MANUFACTURING DRAWING

RUBBER HARDNESS CHANGED			'18.06.22	KAGEYAMA	KATAYAMA				
	EMBOSSING CHANGED			'16.4.14	KAGEYAMA	TOMIWA				
CODE	REVISION HISTORY / CHANGES			DATE	APPD	REV.				
APPROVED	CHECKED	DRAWN	DATE CREATED		SCALE	NAME	ENGINE MOUNT			
KAGEYAMA	YOKOBE	TOMIWA	YEAR MONTH DAY '16. 2. 12		1/1		PART NO.	V1411-42162

IDENTIFICATION (EMBOSSING + MARKING)

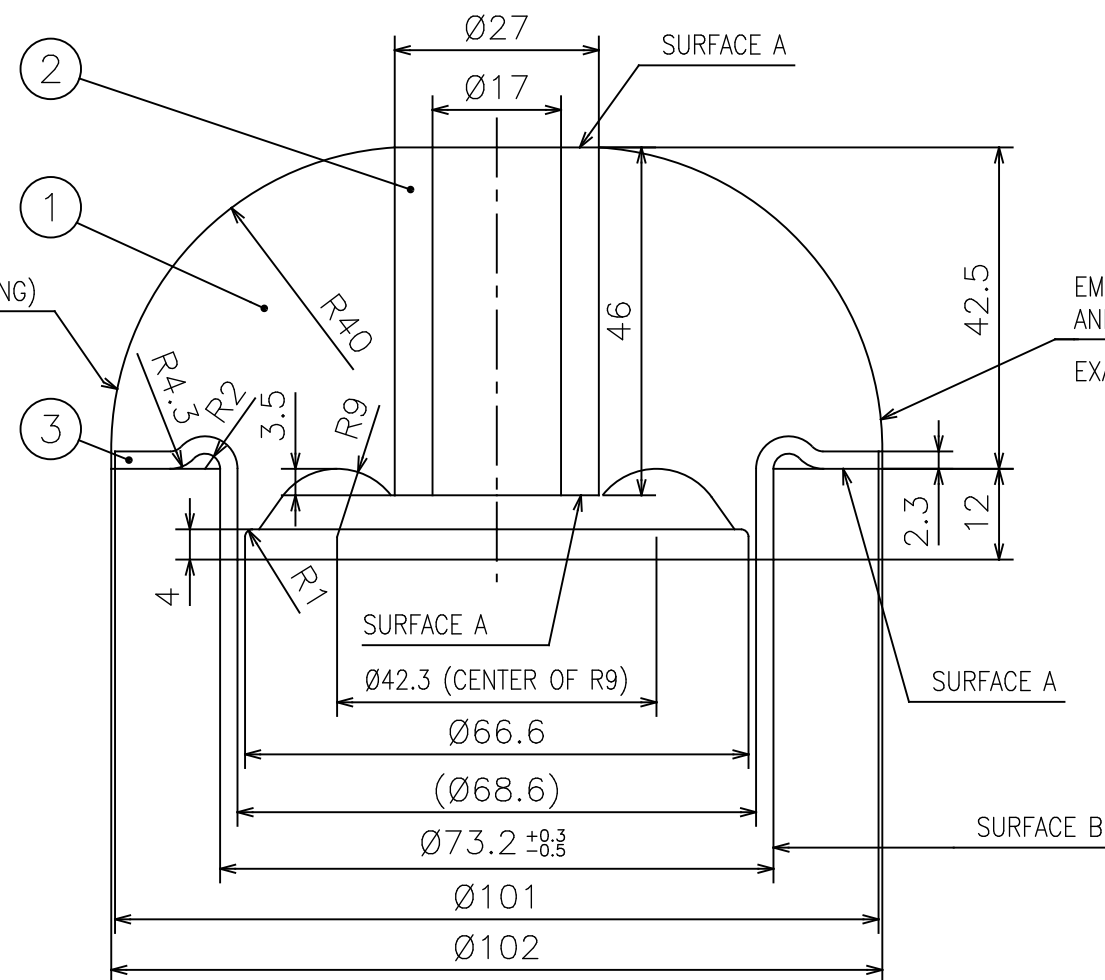
1 ~~42161~~
EMBOSSING: V1411-42162

1. THIS PART DIFFERS FROM V1411-4215A IN STATIC SPRING RATE AND RUBBER SHAPE.
2. THIS PART DIFFERS FROM V1411-42151 AND V1411-4219A IN RUBBER HARDNESS.
- ~~3. THIS PART DIFFERS FROM V1411-42161 IN IDENTIFICATION MARKING.~~
4. SURFACE A (ENTIRE SURFACE) IS A FASTENING SURFACE (SEE INSTALLATION DRAWING);
NO RUBBER FLASH IS PERMITTED.
MARKING RUNS ON SURFACE A (ENTIRE SURFACE) ARE ACCEPTABLE.
NO LOOSE RUBBER FLASH IS PERMITTED ON SURFACE B (ENTIRE CIRCUMFERENCE).
